Tree Survey Summary and Masterplan Assessment

Deerfields Farm, Bodicote

Layout considered: Site Layout Option 2

Report Ref: 3406.Bodicote.RHDHV.TSS

APPENDIX B – TREE CONSTRAINTS AND ASSESSMENT PLAN

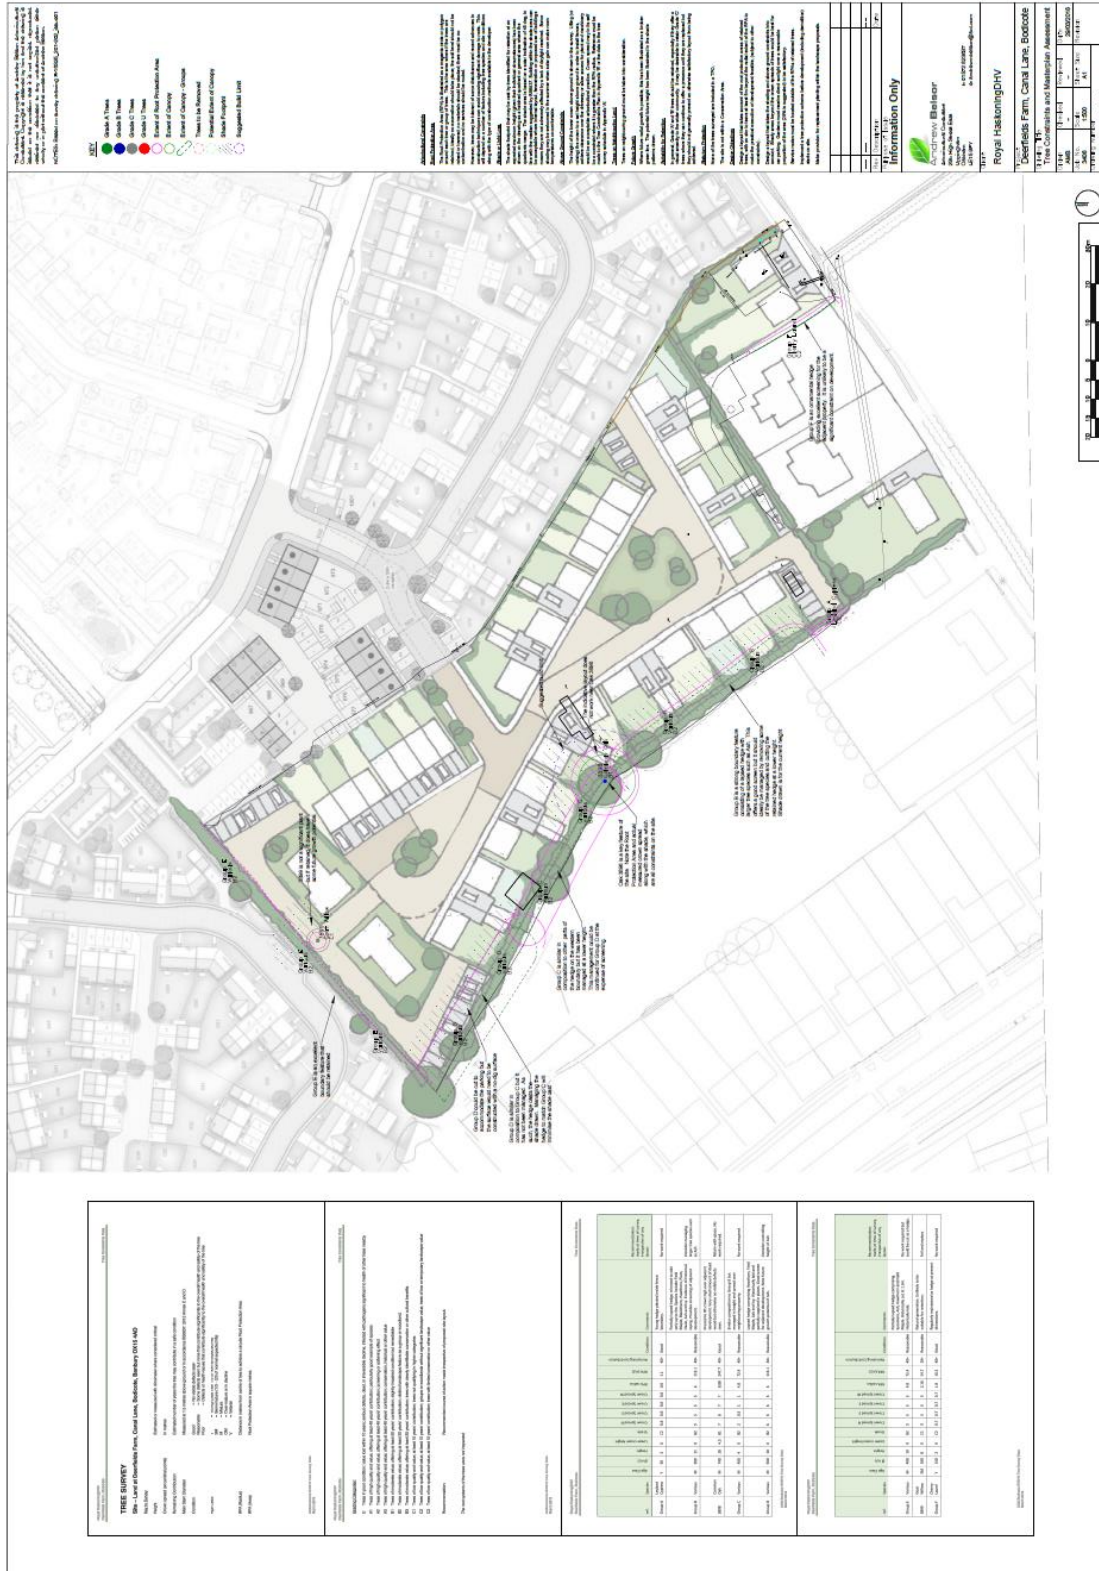
8.1.1 The indicative layout shown on drawing 17/24/02 'Site Layout Option 2' is broadly acceptable but it will need to be adjusted in the region of Oak 3898 in order to successfully incorporate the tree into the layout.

8.2.2 Within the site, the roads and parking areas lie close to the Root Protection Areas of some hedges. This can be overcome through minimising excavation or utilizing no-dog surfacing. However, it would be best to avoid surfacing within rootzones.

8.3.1 The indicative layout is broadly acceptable from an arboricultural perspective but I consider that more space needs to be given between Oak 3898 and any residential buildings, and any garages should be located outside of the tree's RPA.

8.3.2 Goat Willow 3899 cannot be retained in this scheme but I do not consider that to be a significant issue.

8.5.2 Consideration must be given in the layout so that soakaways for dwellings near Oak 3898 can be excavated outside the tree's RPA.

- 8.7.1 Depending on the retained height of hedges B – D, the gardens of dwellings on the western side of the site could be partially affected by shade.
- 8.7.2 Reducing hedge heights will reduce shading but it will also reduce privacy.

- 9.1.1 Retain hedges B – E; cut to a height that balances privacy against garden usability
- 9.1.2 Avoid any construction within Root Protection Areas.

- 9.1.3 Allow a greater distance beyond the edge of the Root Protection Area of Oak 3898 to take account of the tree's size.
- 9.1.4 Assume Goat Willow 3899 can be removed.

- 9.1.5 Design a layout that takes account of the root protection areas of hedges, with an aim to leave at least 2m beyond the radial extent of the RPA to make the practical execution of development feasible, (subject to other constraints)

- 9.1.7 Service routes must be located outside of the RPAs of retained trees.
- 9.1.8 Implement a tree protection scheme before development (including demolition) starts on site.
